**Appendix E**  
**Selected Remedy Cost Estimates**

**Comment Resolution Forms for Draft  
Remedial Design/Remedial Action Work Plan  
and Associated Documents**

Comprehensive Remedial Design/Remedial Action Work Plan for the Test Area North, Operable Unit 1-10, Group 1 Sites (Draft), Field Sampling Plan for Remedial Design/Remedial Action Sampling and Field Screening of Group 1 Sites at Waste Area Group 1, Operable Unit 1-10 (Draft), Operations and Maintenance Plan for Test Area North, Operable Unit 1-10 (Draft), Waste Management Plan for the Test Area North, Operable Unit 1-10, Group 1 Sites Remedial Action (Draft)

Figure F-1. Sampling locations at the Fuel Leak site (WRTF-13).

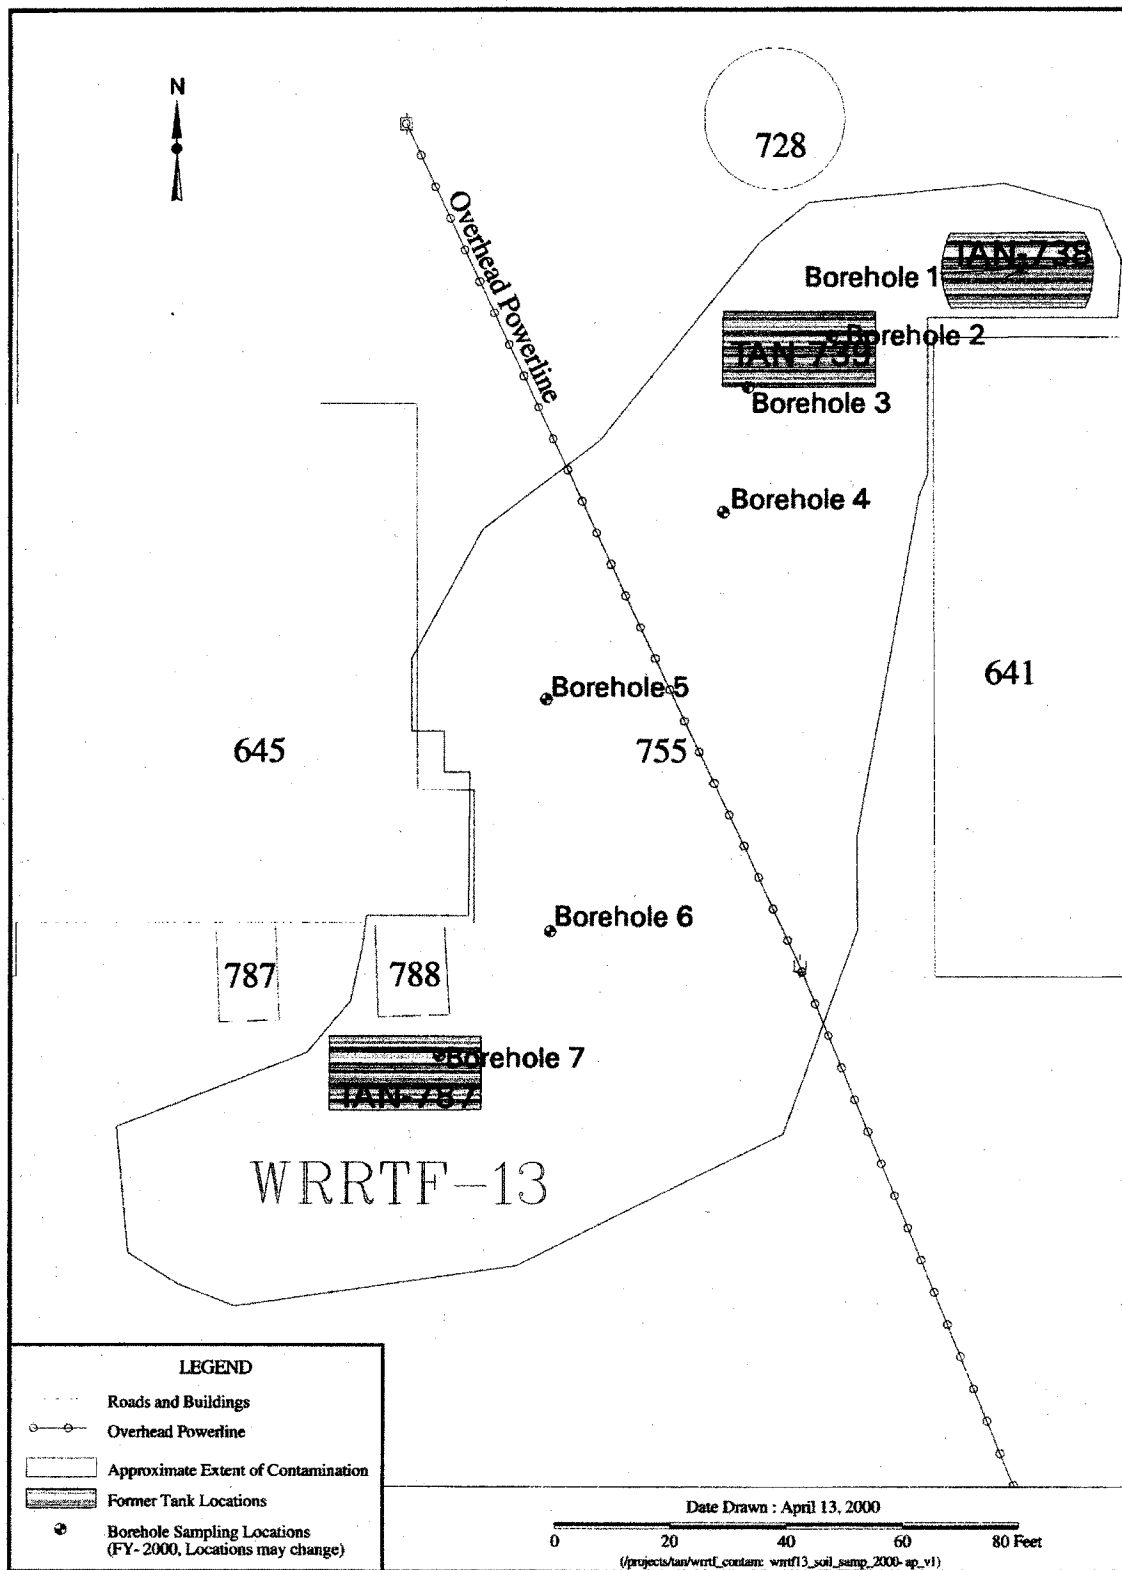
14	Appendix G	P. G1-7 to G1-8	<p>WRTF-13 Post-ROD Sampling Data and RBCA Analysis</p> <p>Based on the results of the RBCA analysis in Appendix G, DOE states elsewhere in the document (see Specific Comment 5) that "no excavation will be performed at the Fuel Leak site. However, in reviewing the RBCA print-outs in Appendix G, the following problems associated with the analysis were found:</p> <p>On Page G1-7, <i>Complete Pathway(s) and Route(s) of Exposure</i>, it is indicated in the "Protection of Groundwater" category that the groundwater is a class 2. This is not correct. Groundwater in the Snake River Plain aquifer is a Class 1 groundwater.</p>	<p>Groundwater class 2 was chosen for the model based upon significant INEEL groundwater modeling experience. Groundwater class 2 flow is at a rate of approximately 1 ft/day. Actual Snake River Plain Aquifer flow at the INEEL is known to be approximately 4.5 ft/day. Groundwater class 2 is a more conservative assumption to use than the true known flow rate. In the June 27, 2000 conference call with Mr. Bruce Wierski of IDEQ, the groundwater class 2 assumption was discussed and agreed to be acceptable for use in the Appendix G RBCA model.</p>

ITEM NUMBER	SECTION NUMBER	PAGE NUMBER	COMMENT	RESOLUTION
14 (cont.)			<p>On Page G1-8, Exposure Parameters for Routes of Exposure, the "Exposure Frequency" for the days of exposure per year were cut to 180 days which it states are the Tier 1 default parameters. This is incorrect. Table 6-1 of the IDRA manual provides "350 days" for a Tier 1 default for the exposure frequency.</p> <p>It is recommended that the parameters that were used be reviewed, and the model be rerun with the suggested changes and submitted again for DEQ review.</p>	<p>The commentor is correct that Table 6-1 of the Idaho RBCA manual provides 350 days for a Tier 1 default for the exposure frequency for surficial soil. However, the Idaho RBCA model uses 180 days for a Tier 1 default for the exposure frequency for surficial soil. It was confirmed with Mr. Bruce Wicherski of IDEQ during the June 27, 2000 conference call that 180 days for a residential scenario, and 40 days for a commercial scenario are the correct numbers for surficial soil.</p> <p>No changes were made to the RBCA model. The June 27, 2000 conference call with Mr. Bruce Wicherski of IDEQ provided guidance on several aspects of textual explanation provided as page G-1 in Appendix G. This page will be revised for the draft final revision of this RDR/RAWP.</p>
